MONTGOMERY COUNTY PLANNING DEPARTMENT
THE MARYLAND-NATIONAL CAPITAL PARK AND PLANNING COMMISSION

MCPB 09/25/08
Item #6

MEMORANDUM

SUBJECT: MCER NO. 29-08: PROPOSED DEPARTMENT OF FIRE AND
RESCUE SERVICE REGULATION, Fire Safety Code – Fire Department
Apparatus Access and Water Supply

Figure 1. Operating bay application sketch

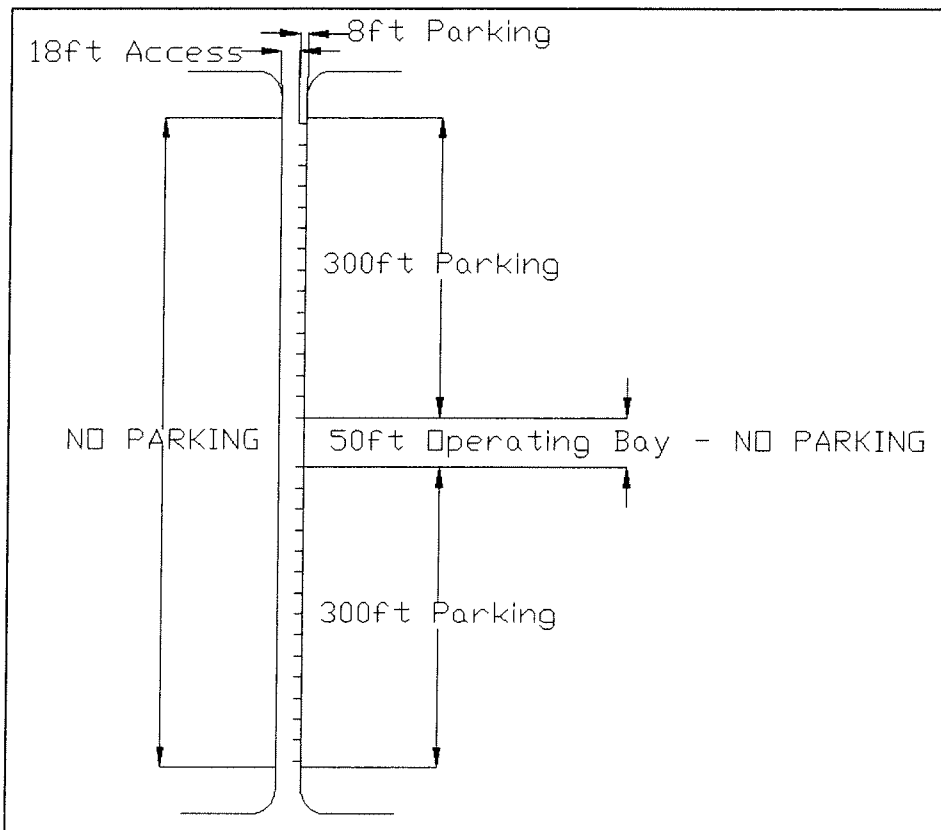
We recommend that the regulation include language that allows parking on both sides of 26-foot-wide roads if the street pattern in the area would otherwise allow adequate fire access.
